Project	IEEE 802.16 Broadband Wireless Access Working Group < http://ieee802.org/16 >
Title	Peer-to-peer File Sharing Traffic Model for IEEE 802.16m EVM
Date Submitted	2008-01-16
Source(s)	Kelvin Chou Kelvin.chou@mediatek.com Paul Cheng paul.cheng@mediatek.com MediaTek Inc.
Re:	Call for Comments on Draft 802.16m Evaluation Methodology Document
Abstract	This contribution proposed a traffic model for peer-to-peer file sharing applications.
Purpose	Adopt this contribution to insert a new subsection in section 10.
Notice	<i>This document does not represent the agreed views of the IEEE 802.16 Working Group or any of its subgroups. It represents only the views of the participants listed in the "Source(s)" field above. It is offered as a basis for discussion. It is not binding on the contributor(s), who reserve(s) the right to add, amend or withdraw material contained herein.</i>
Release	The contributor grants a free, irrevocable license to the IEEE to incorporate material contained in this contribution, and any modifications thereof, in the creation of an IEEE Standards publication; to copyright in the IEEE's name any IEEE Standards publication even though it may include portions of this

Figure 1: BitTorrent traffic pattern

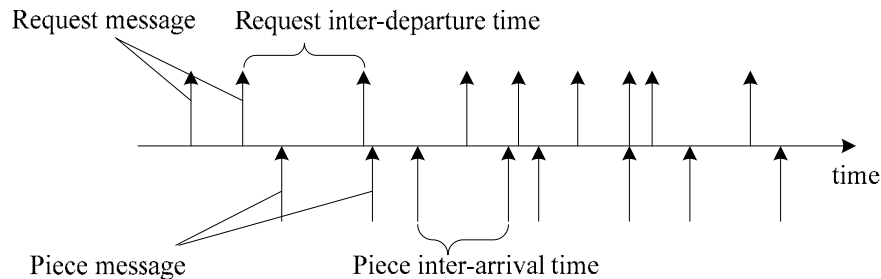
-----Start of the Text-----
[In IEEE 802.16m-07/037r2, insert the following section after section 10.7]

10.8. Peer-to-peer File Sharing Traffic Model

For simplicity, all leech peers (peers that do not have the entire content) are assumed to be interested in a piece of infinite size, and will not be choked by any remote seed peers (peers that have the entire content). Therefore, leech peers continuously send requests for blocks and receive piece messages containing the requested blocks. Both the request inter-departure time and piece inter-arrival time can be modeled by the exponential distribution [3], [4], [5]. The simplified BitTorrent traffic pattern is illustrated in Figure 1.
